**INDEPENDENT REVIEW OF BUSHFIRE IMPACT
PLANNING PROPOSAL
TO
REZONE LAND AT 95 – 97 STANHOPE ROAD,
KILLARA**

Report Number	Document	Preparation Date	Issue Date	Directors Approval
B183160-2	Final	06.04.2018	14.05.2018	<i>G.L.Swain</i>

Australian Bushfire Protection Planners Pty Limited has been commissioned by *Ku-ring-gai Council* to undertake an independent review of the bushfire impact of the Planning Proposal to rezone land at No. 95 – 97 Stanhope Road, Killara.

Figure 1 – Plan of Potential Fire Paths

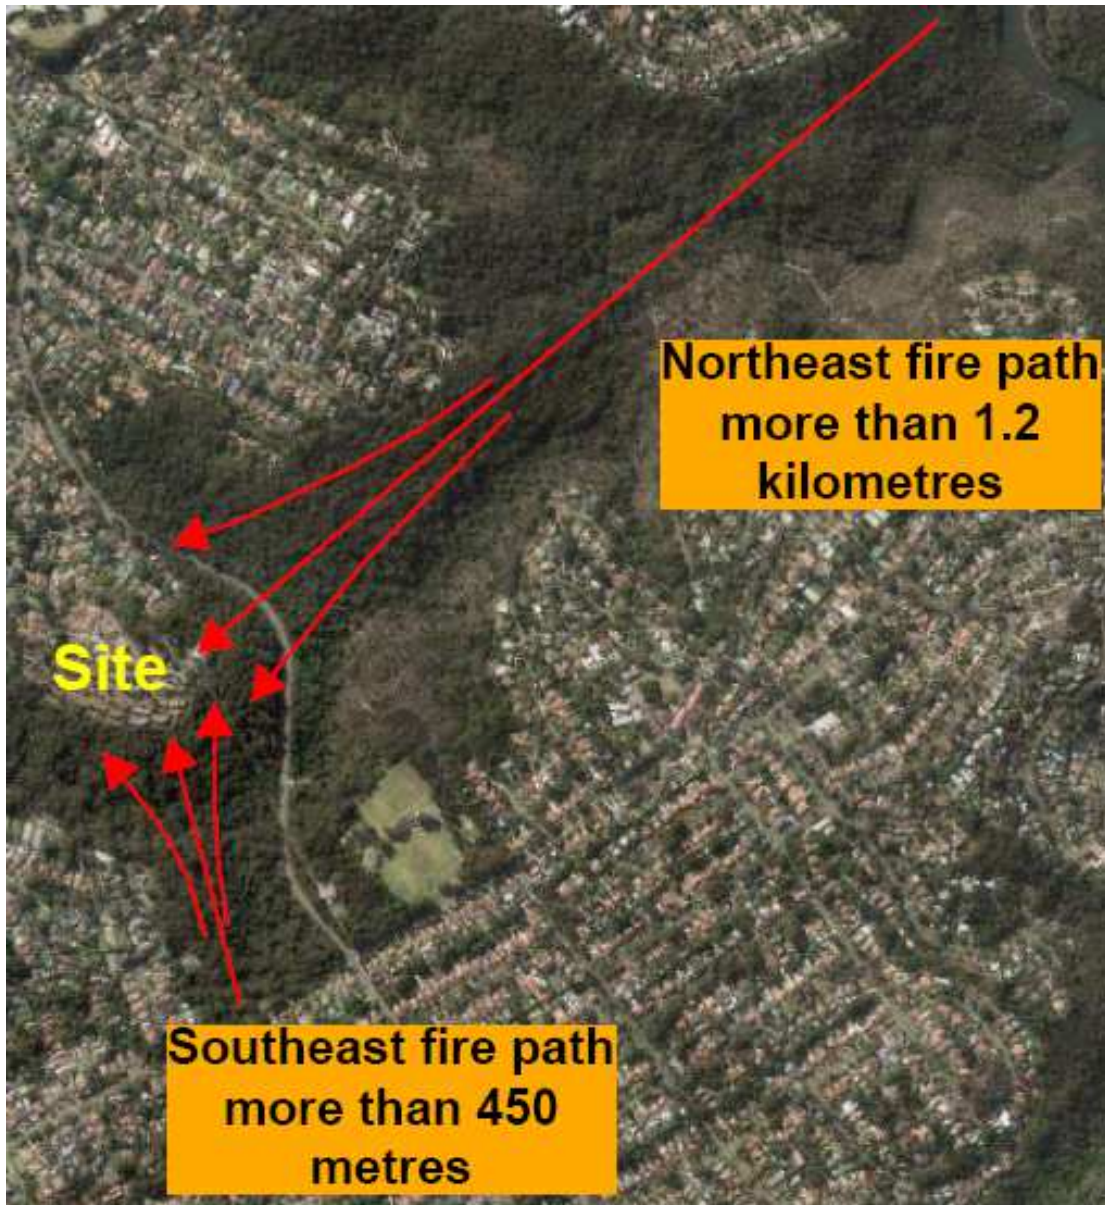
Figure 1 on Page 10 of this report provides a graphical representation of the fire paths which are likely to present a hazard to the site and identifies that there is a 1.2 klms fire path from the northeast with a potential head width of more than 300 metres.

The fire path from the southeast has a length of more than 450 metres with a potential head width of more than 250 metres.

Figure 3 – Plan showing 100 metre and 60 metre wide Asset Protection Zone setback line.

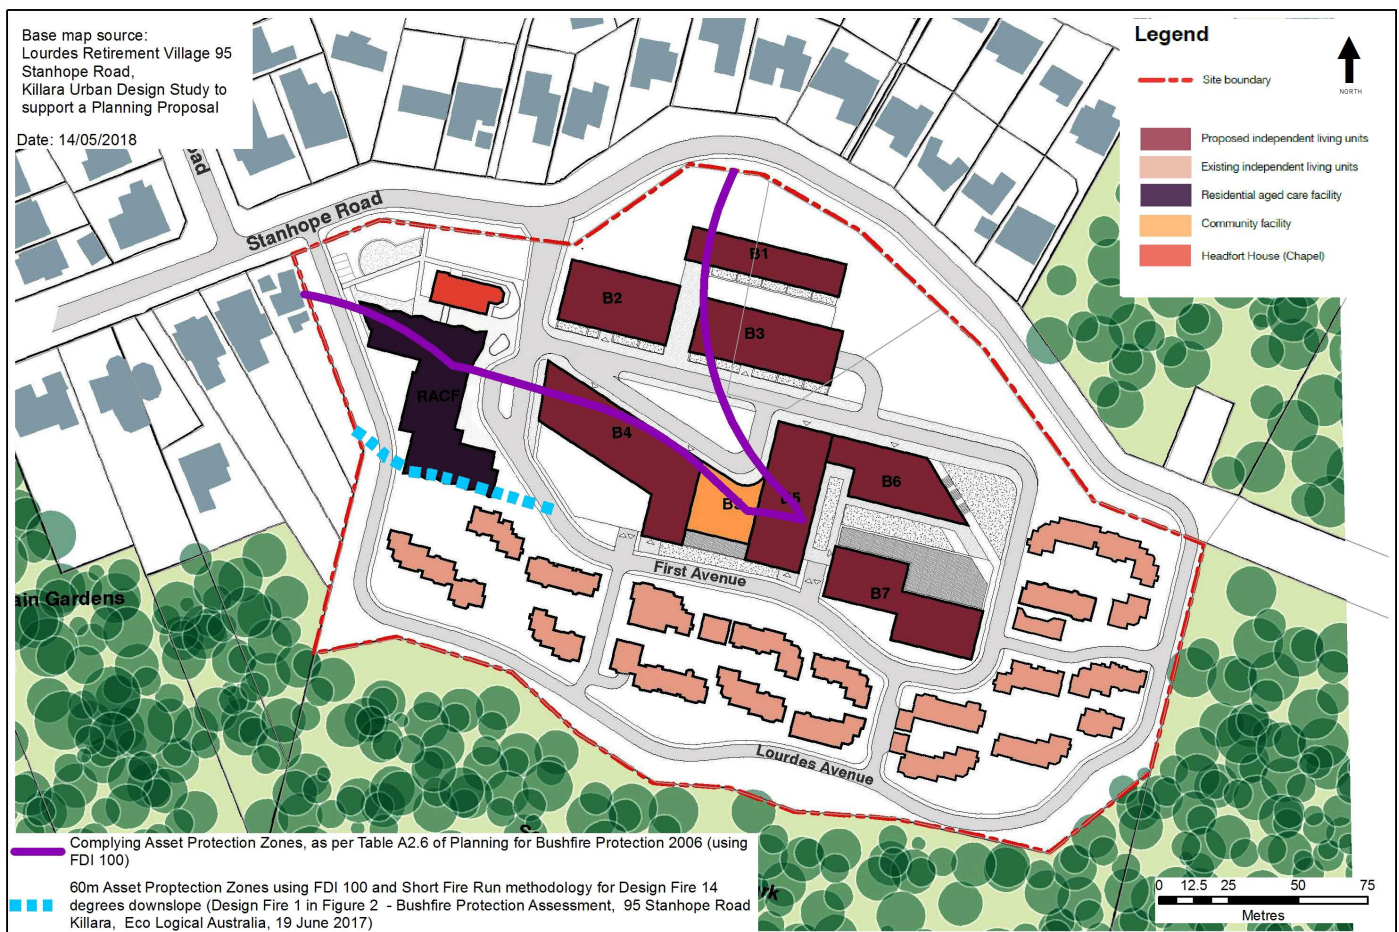
Table A2.6 *Planning for Bushfire Protection 2006* requires that for effective slopes of more than 10 degrees, having forest as the predominant vegetation type, the Asset Protection Zone is 100 metres in order to achieve a radiant heat rating on the exterior of the buildings of no greater than 10kW/m².

The Planning Proposal locates the new buildings closer to the hazard than the required 100 metre wide setback [Asset Protection Zone] and therefore does not address the mandatory NSW Rural Fire Service performance standard for *Special Fire Protection Purpose Development* as required by Section 4.2.7 of *Planning for Bushfire Protection 2006*.

Figure 3 on Page 13 of this report showing the 100 metre wide Asset Protection Zone setback line.

The ELA report utilises a Short Fire Run calculation to justify the Asset Protection Zone setback to the southwest. The maximum length of fire path [run] accepted by the Rural Fire Service in Short Fire Run calculations is 150 metres.

Except for the Design Fire 14 degree downslope fire path to the southwest, which has a fire run distance of 147 – 150 metres, all other fire paths exceed the 150 metre length and therefore preclude the use of the Short Fire Run Calculator. The Planning Proposal provides a setback of around 58m (but a required APZ of 55 metres) to the southwest of the new RACF building. Using the Short Fire Run methodology and FDI 100, a distance of 60m is required to provide radiant heat of less than 10kW/m² to this aspect of the building, as mapped within Figure 3

Figure 4 – Plan showing location of high risk access road.

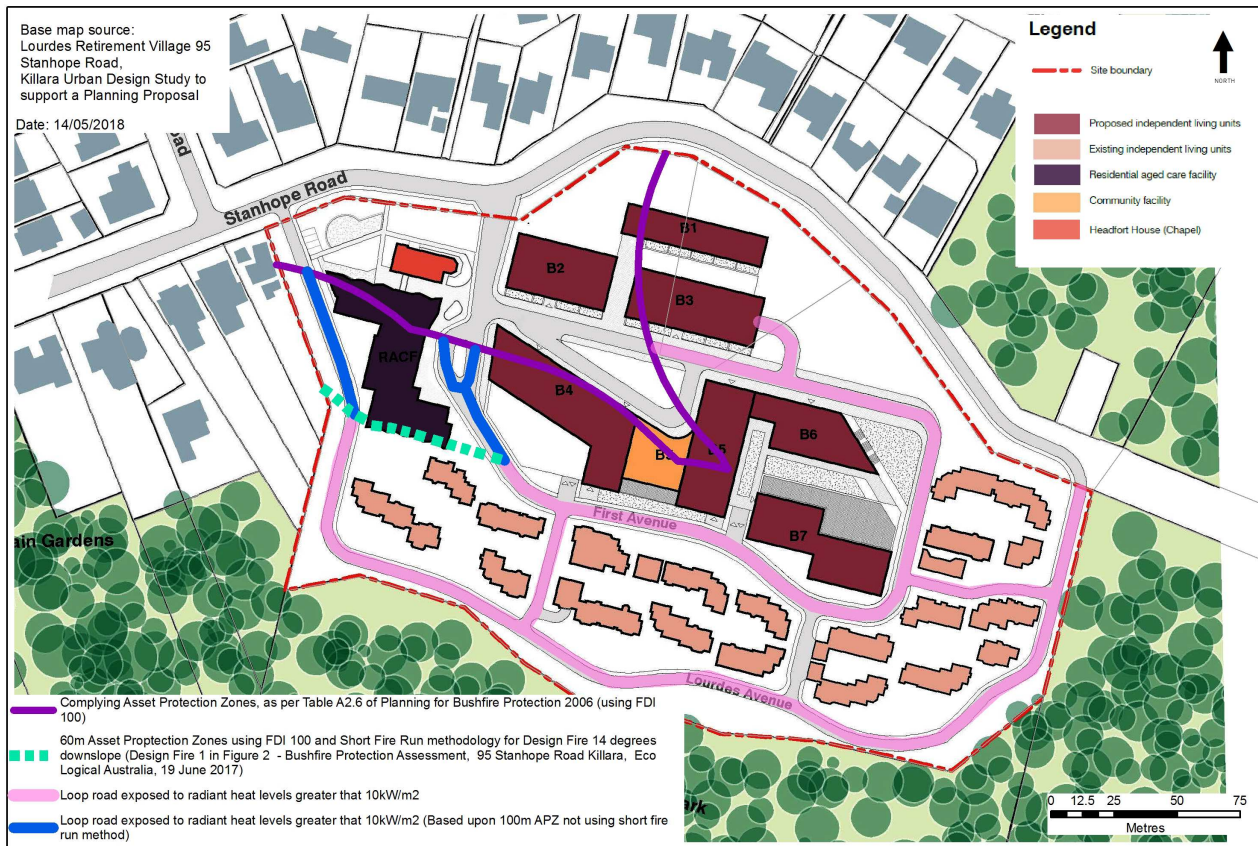
Section 8 of the ELA report examines the existing and proposed access arrangements under the Planning Proposal with the proposal to provide a secondary access to Stanhope Road. This improves emergency egress from the site except that the existing perimeter access road linking to the secondary exit is not safe and will be subject to bushfire over-run.

The Planning Proposal establishes a loop perimeter internal road identified as 'First Avenue'. A review of the likely impact on this road has identified that with the use of the increased Fire Danger Rating for the site the north-eastern, eastern and south-eastern sections of the loop will be exposed to radiant heat levels greater than 10kW/m². This section of the loop road will therefore not provide safe access/egress for residents and an operational platform for fire-fighters assisting during bushfire. Refer to Figure 4 on Page 15 of this report.

Figure 5 – Plan showing 100 metre wide Asset Protection Zone setback and 29kW/m² (61m) setback line.

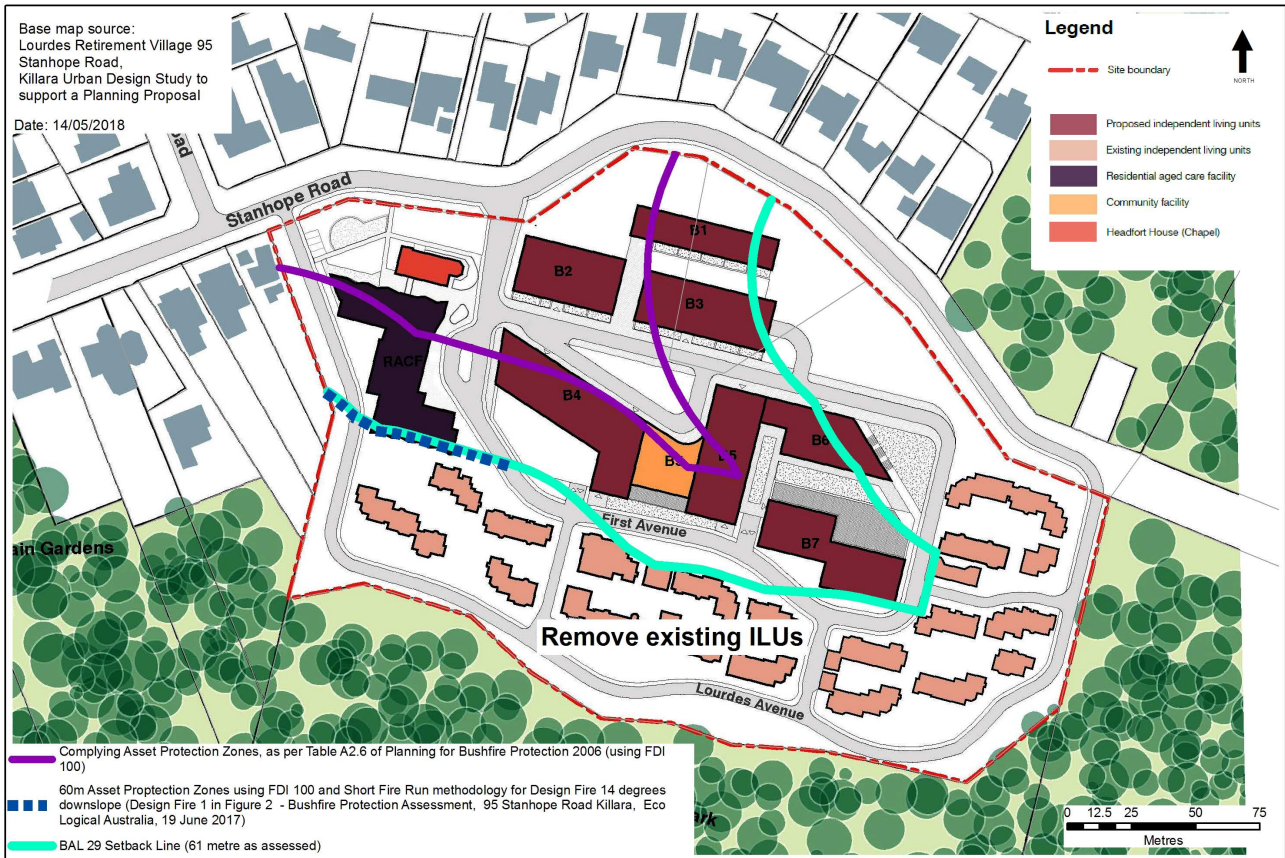
The site is not capable of accommodating the development as detailed in the proposed Master Plan as the setbacks proposed do not comply with the requirement that the exterior of the buildings have a radiant heat exposure of not more than 10 kW/m².

In order to justify redevelopment on the site discussions should be held with the NSW Rural Fire Service to confirm whether the Service is prepared to consider reducing the width of Asset Protection Zones and is also prepared to accept an increase in the level of radiant heat exposure on the exterior of the new buildings to BAL 29.

If the Service confirms support for a reduction in the width of the Asset Protection Zones and an increase in the level of radiant heat above 10kW/m² the Master Plan should be redesigned achieve the required standards.

The occupancy numbers shall also be reduced to lower the number of persons requiring evacuation from the buildings located in the 29 kW/m² setback distance. This will depend on the NSW Rural Fire Service's acceptance of an increase in the radiant heat level from 10kW/m² to 29kW/m².

The existing ILUs proposed to be retained on the periphery of the site shall be removed and the area managed as an Asset Protection Zone. The existing perimeter road shall be retained for fire-fighting and maintenance access and the internal road redesigned to provide access to the buildings and a second connection to Stanhope Road, located inside the 10kW/m² setback – refer to Figure 5 on Page 18 of this report.
